**Final Staff Report Including the Final Substitute Environmental Documentation
Adopted May 6, 2015**

Amendment to the Water Quality Control Plan
For Ocean Waters of California

DESALINATION FACILITY INTAKES, BRINE DISCHARGES, AND THE INCORPORATION OF
OTHER NON-SUBSTANTIVE CHANGES

May 6, 2015

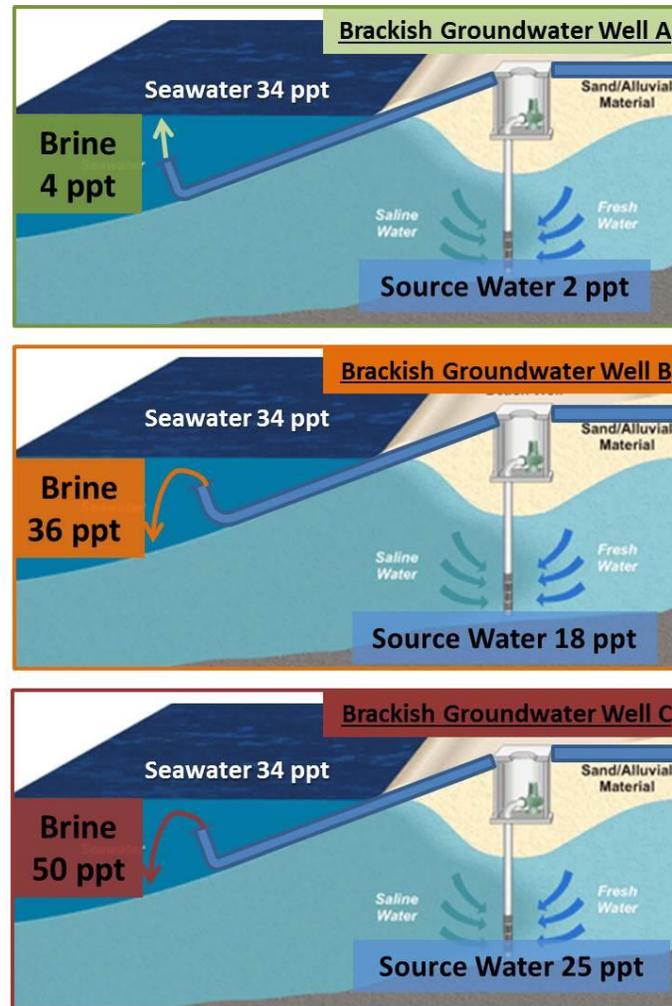
ID#	Comment Summary	Response
		<p>for salinity that would apply to all brackish groundwater desalination facilities in California.</p> <p>Figure 8.1-1 below presents three brackish groundwater desalination facilities with different source water and brine salinities measured in ppt. The figure illustrates how varying salinity of source water can influence the density of the discharged plume. Facility A produces a positively buoyant “brine” plume that would not affect the benthic marine environment. Facilities B and C would form dense, negatively buoyant plumes that could negatively affect the benthic marine environment if not properly discharged.</p> <p>Currently, regional water boards issue waste discharge permits (either WDRs or NPDES permits) for brackish water desalination facilities on a case-by-case basis. More research is needed to identify an appropriate statewide limitation to apply to brine discharges from brackish groundwater desalination facilities. The Staff Report with SED does not adequately study brackish groundwater desalination facilities and staff would need additional time to research the impacts associated with the facilities and incorporate the information. Furthermore we would need to meet with stakeholders in the brackish groundwater desalination facility community to solicit feedback on the proposed Desalination Amendment language. Brackish groundwater desalination facilities are currently regulated by the regional water boards on a case-by-case basis. However, if there is sufficient public interest the State Water Board may address the issue in a subsequent amendment to the Ocean Plan.</p>
